AS-BUILT

key plan
2nd FLOOR LITS
STEINBERG ARCHITECTS

SECOND FLOOR PLAN

E2.02

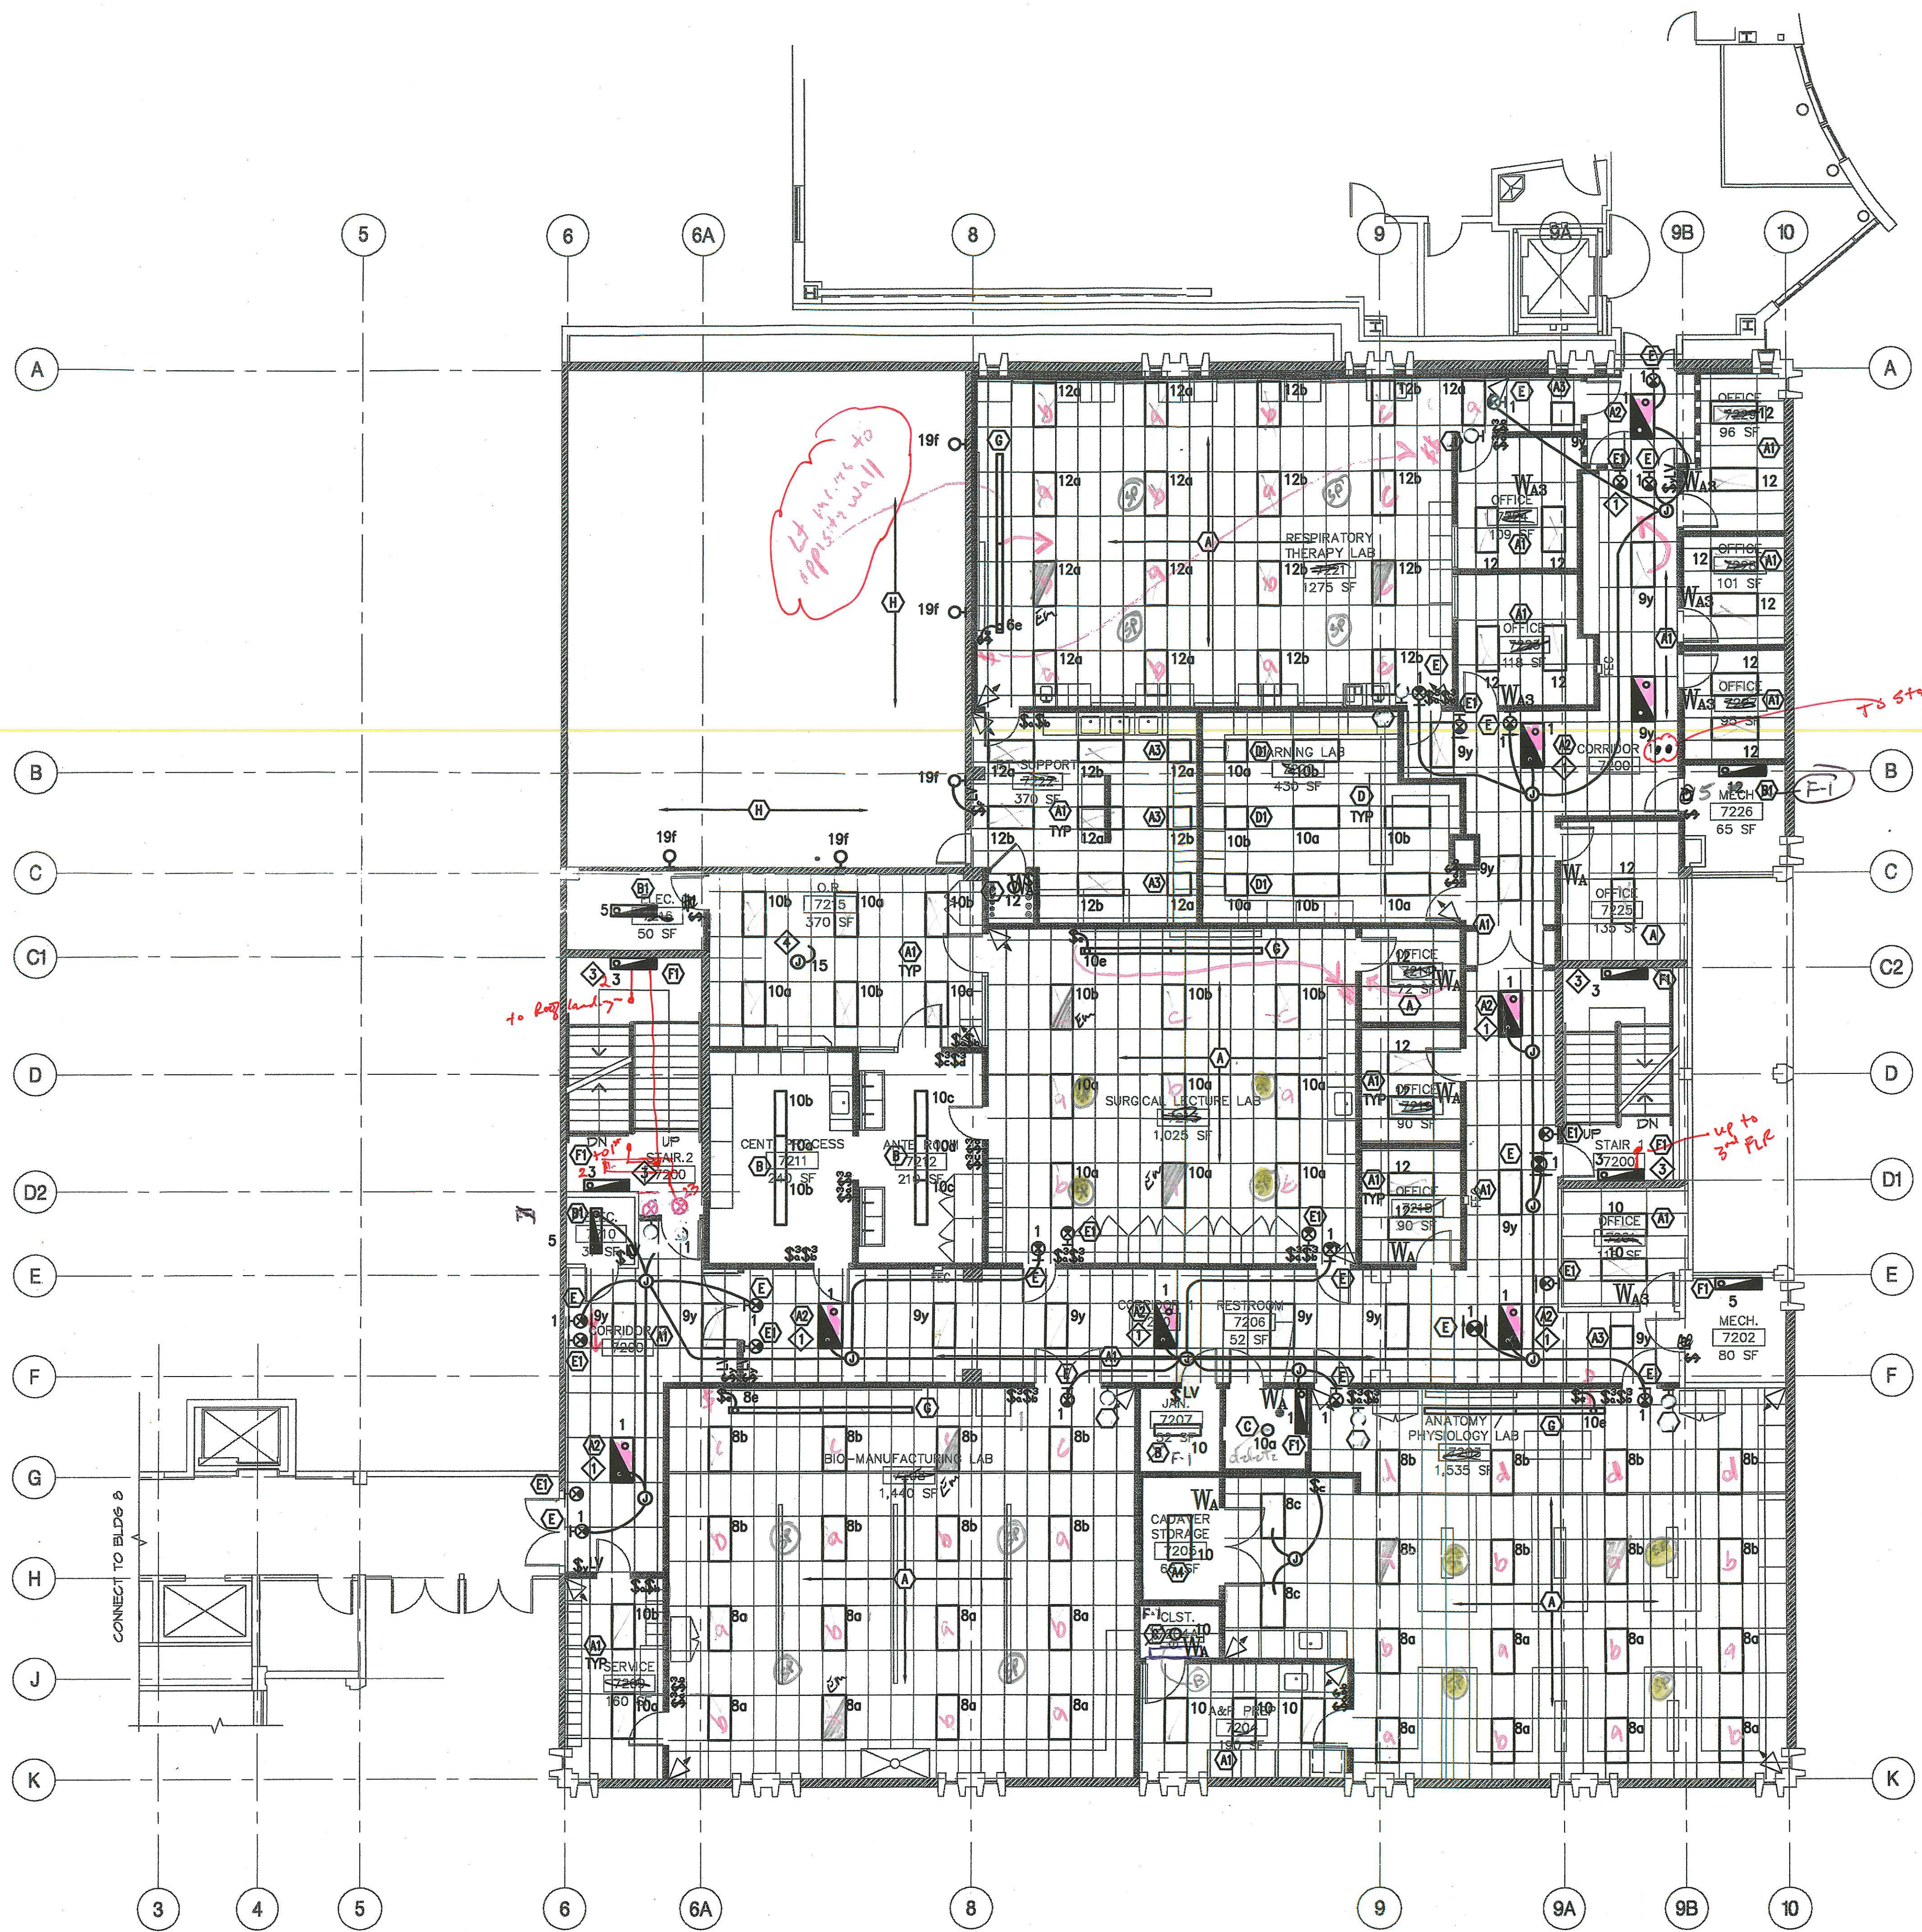
clocks
- 18th -

2x4's
A-1-3-9
2x A-2-8
2x2 A-3-4
A-6-1
A-4-1
D-1-5
2x2 D-1-3
116 Total

carbon units
15

1,5-9
8,10,12

(5)-F-1

8-EM LITS ADDE

ask 4/w m/c 3 way SW
in Rm 7203 } for Em Lighting
7213
